CONTRACT CHANGE ORDER

CCO: 63 **Suppl. No. 0** **Contract No. 04 – 0120F4** **Road** SF-80-13.2/13.9 **FED. AID LOC.:**

Within the tower shaft, modify the longitudinal stiffeners, additional field welding channels in the diaphragm and cut holes in the diaphragm as shown on sheets two (2) through seven (7) of this change order. The following revised contract plan sheets detail all changes: 0546R2, 0556R2, 0583R2, 0590R1, 0591R1 and 0592R2 (of 1204).

SAN FRANCISCO OAKLAND BAY BRIDGE
EAST SPAN SEISMIC SAFETY PROJECT
SELF-ANCHORED SUSPENSION BRIDGE
(SUPERSTRUCTURE & TOWER)

TOWER SPLICE DETAILS NO. 7

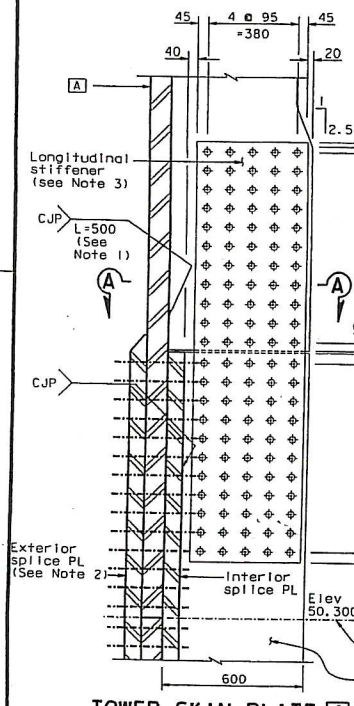
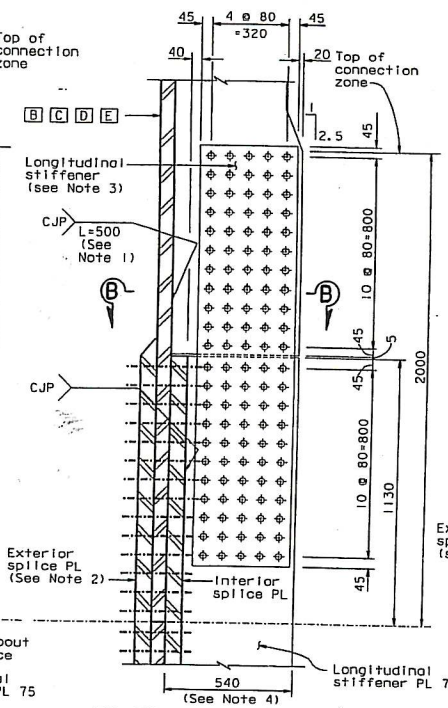
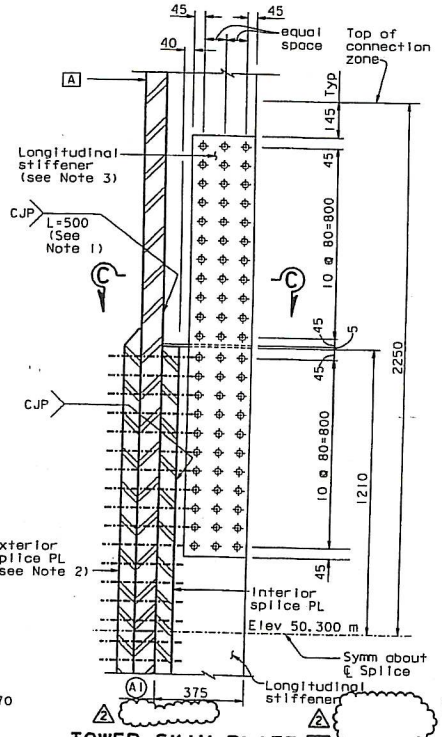
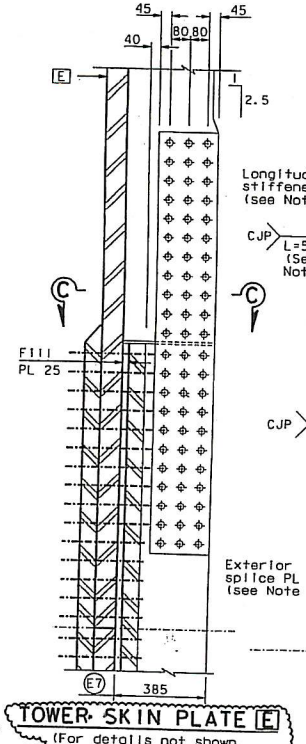
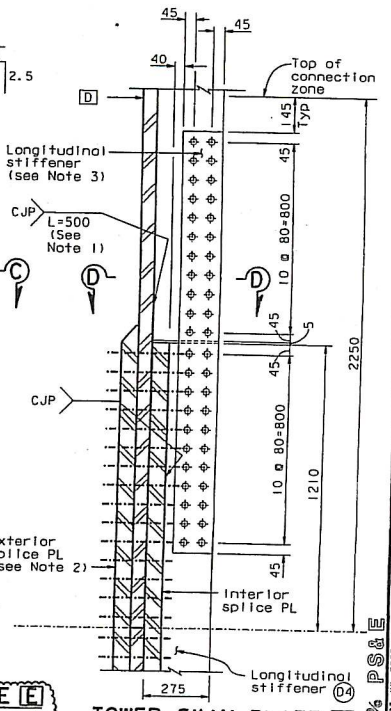
MARK	DATE	DESCRIPTIONS	BY	CH'D	CCO#
		REVISIONS			
2	07/11/08	TOWER INTERNAL SHAFT	MN	NV	63
1	06/23/06	LONG STIFFENER GAP & MISC	MN	NV	21

TOWER SPLICE DETAILS NO. 17

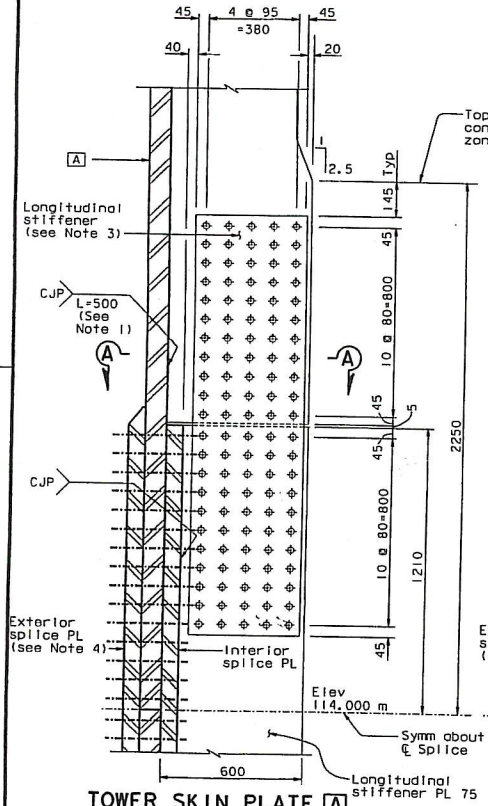
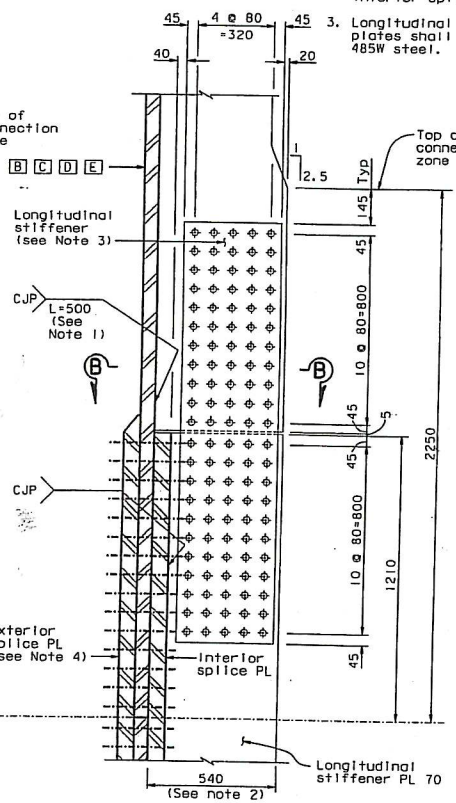
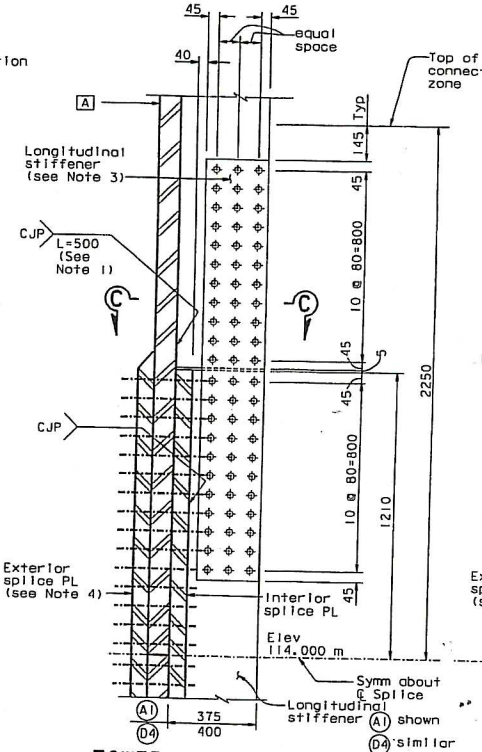
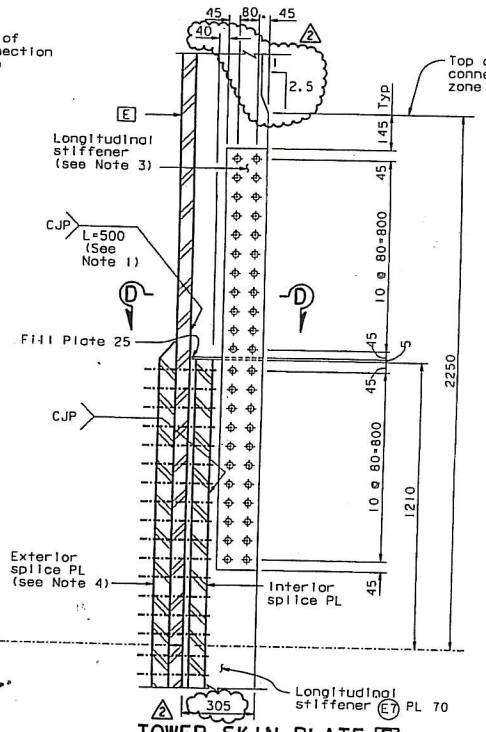
MARK	DATE	DESCRIPTIONS	BY	CH'D	CCO#
2	07/11/08	TOWER INTERNAL SHAFT	MN	NV	63
1	06/21/06	LONG. STIFFENER GAP & MISC.	MN	NV	21

TOWER DIAPHRAGM DETAILS NO. 8

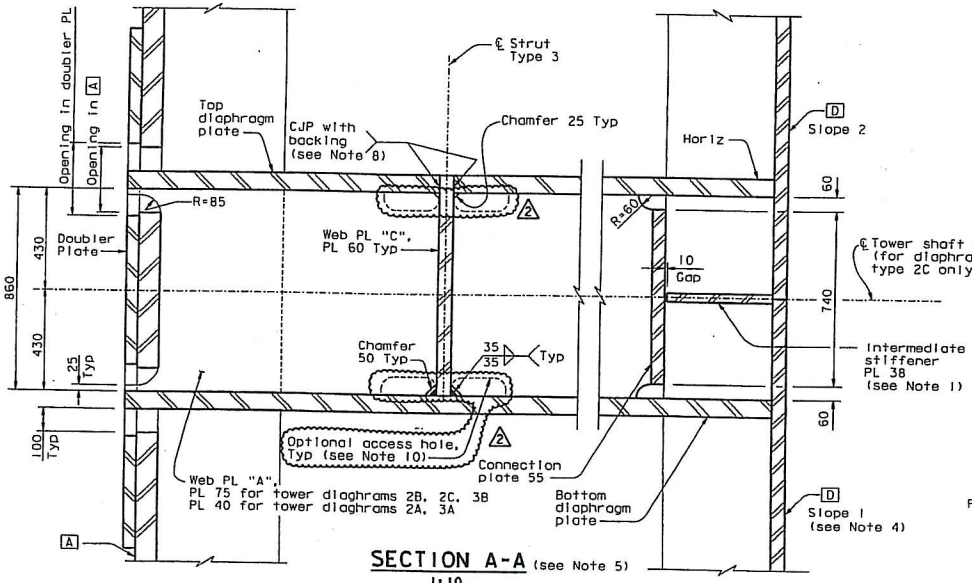
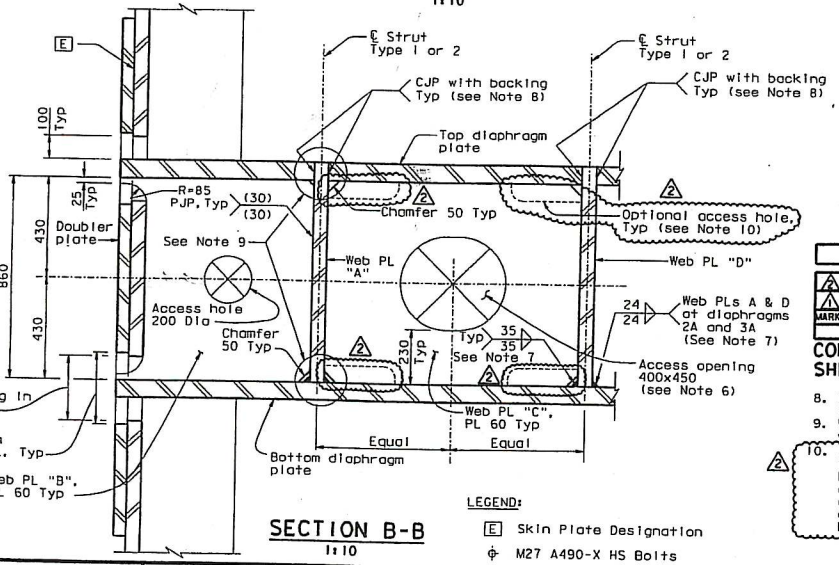
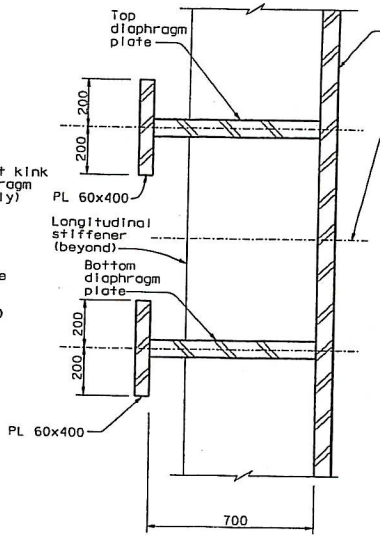
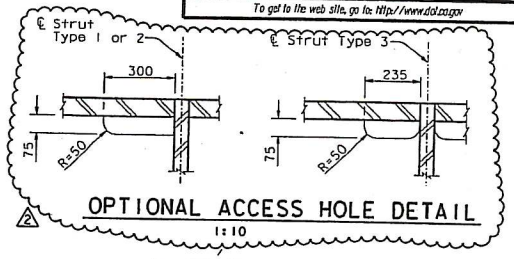
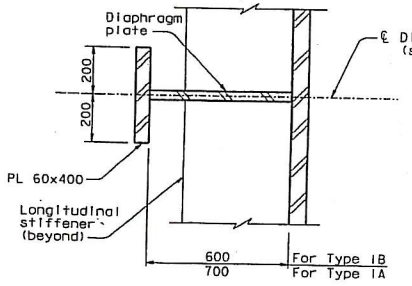
REQUESTS FOR INFORMATION NOT ADDRESSED IN THIS CCO REMAIN IN FORCE				
2	07/11/08	TOWER INTERNAL SHAFT	MN	NV	63
1	06/23/06	WEB PL TO DIAPHRAGM PL WELD	MN	NV	21
MARK	DATE	DESCRIPTIONS	BY	CH'D	CCO#
REVISIONS

8. For alternate web plate to diaphragm plate weld, see Detail A.
9. Weld joint details shown at top and at bottom of web plate are interchangeable for all web plates.
10. At the Contractor's option, access holes may be provided to facilitate strut erection. Access holes for strut Type 3 apply at all tower strut elevations. Access holes for strut Type 1 apply at elevation 119 m. Access holes for strut Type 2 apply at elevation 143 m. See "Optional Access Hole Detail".

TOWER DIAPHRAGM DETAILS NO. 15

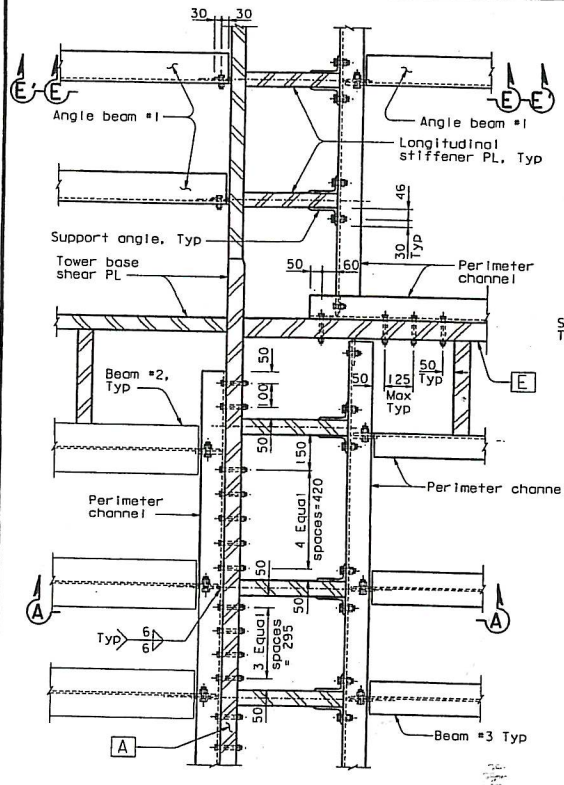
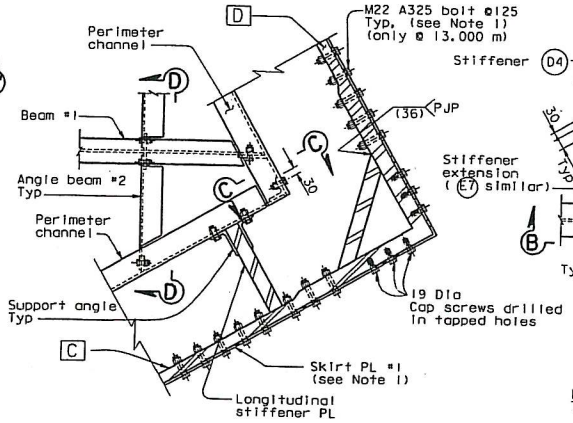
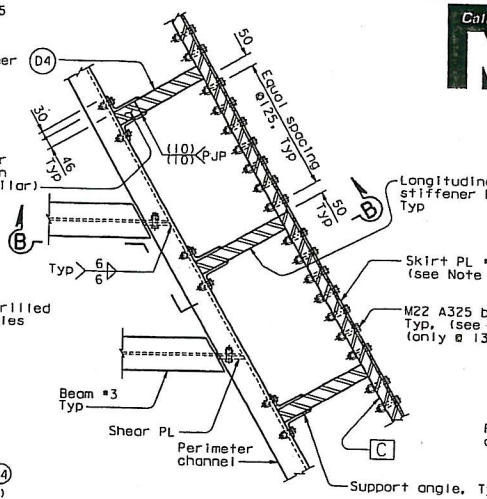
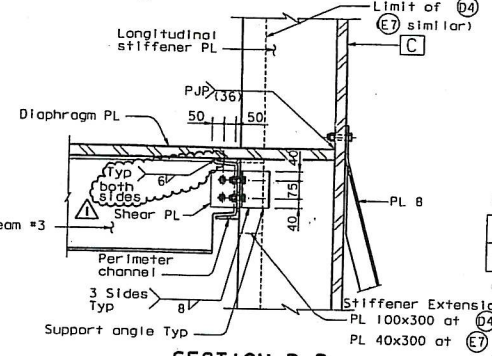
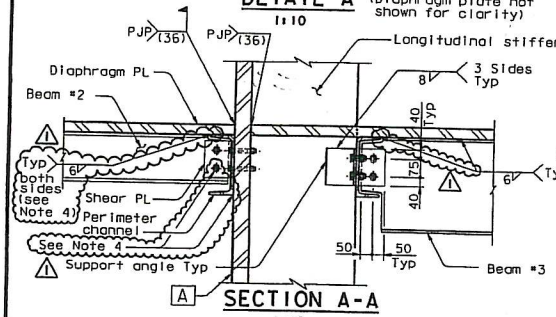
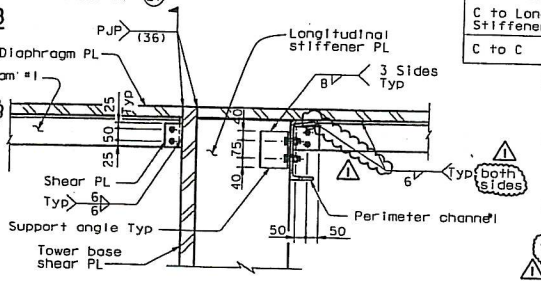
MARK	DATE	DESCRIPTIONS	BY	CH'D	CCO#
1	07/11/08	TOWER INTERNAL SHAFT	MN	NV	63

TOWER DIAPHRAGM DETAILS NO. 16

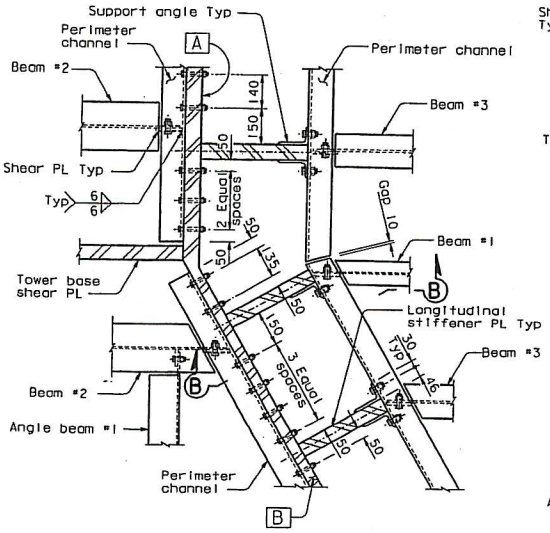
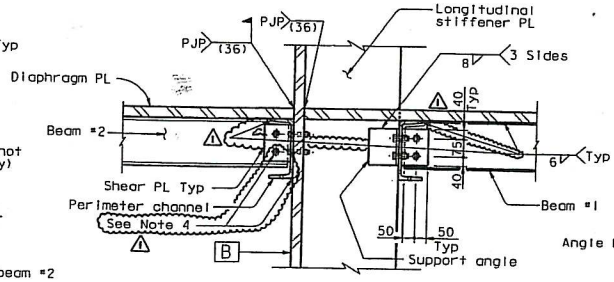
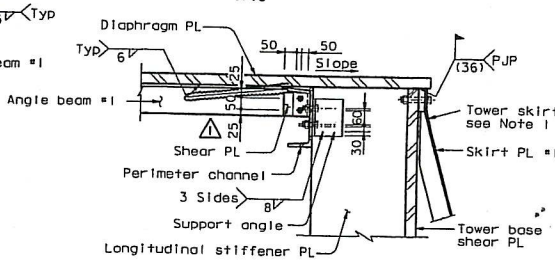
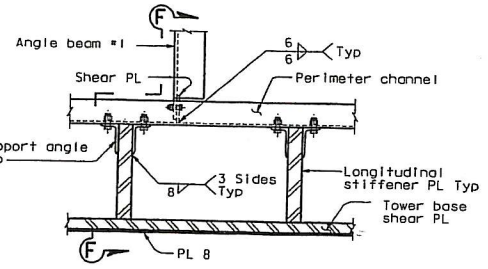
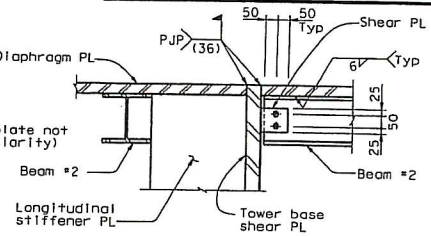
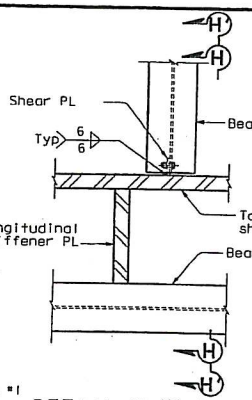
MARK	DATE	REVISIONS	BY	CH'D	CCO#
1	07/11/08	TOWER INTERNAL SHAFT	MN	NV	63

TOWER DIAPHRAGM DETAILS NO. 17

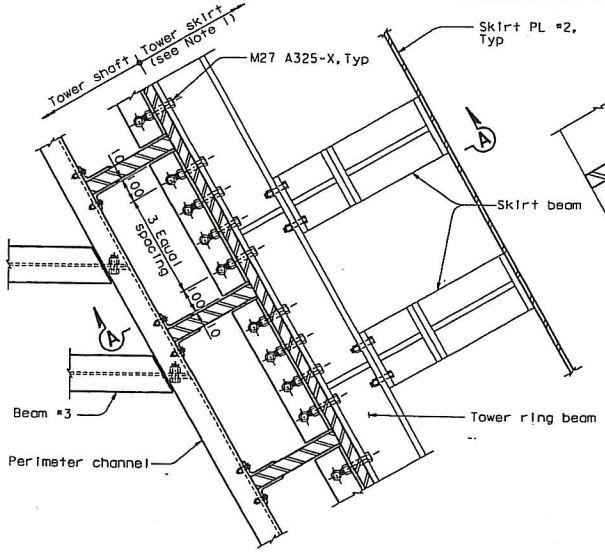
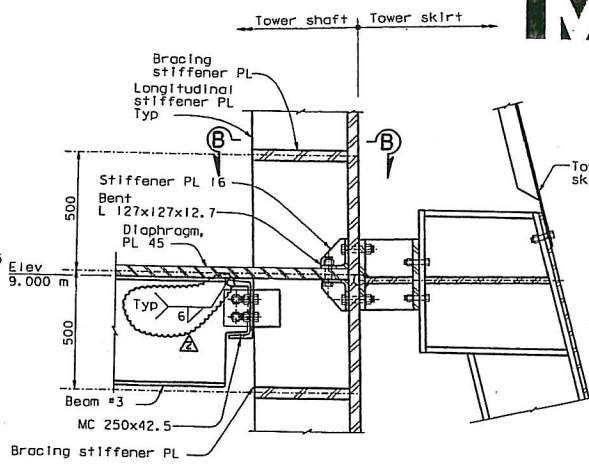
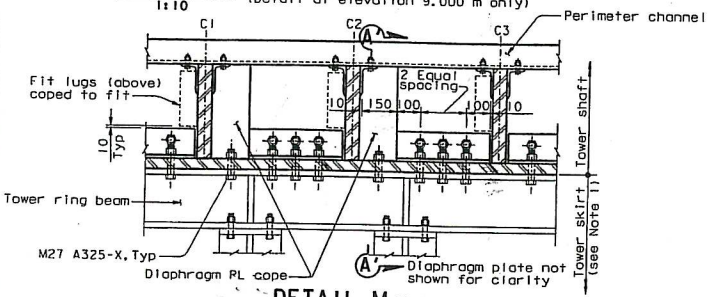
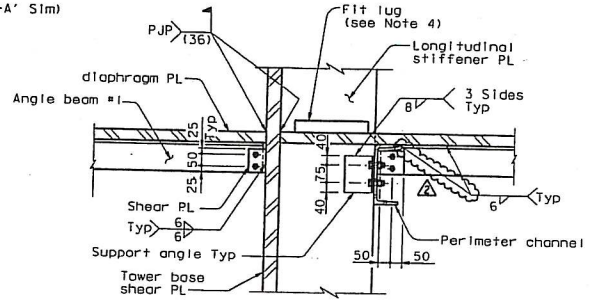
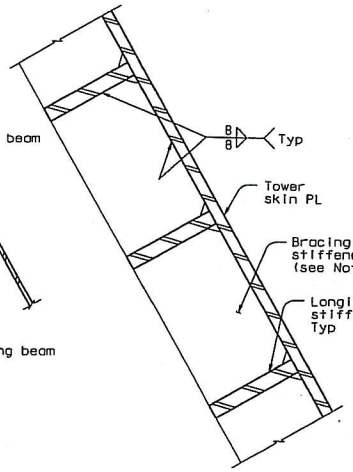
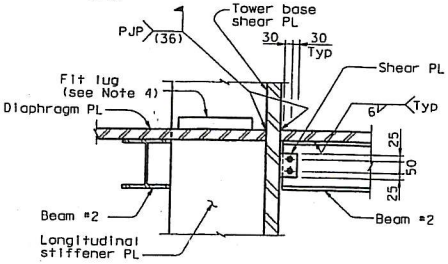
MARK	DATE	DESCRIPTIONS	BY	CH'D	CCO#
		REVISIONS			
2	07/11/08	TOWER INTERNAL SHAFT	NV	MN	63
1	09/01/07	ELECTRICAL MODIFICATIONS	NV	MN	42
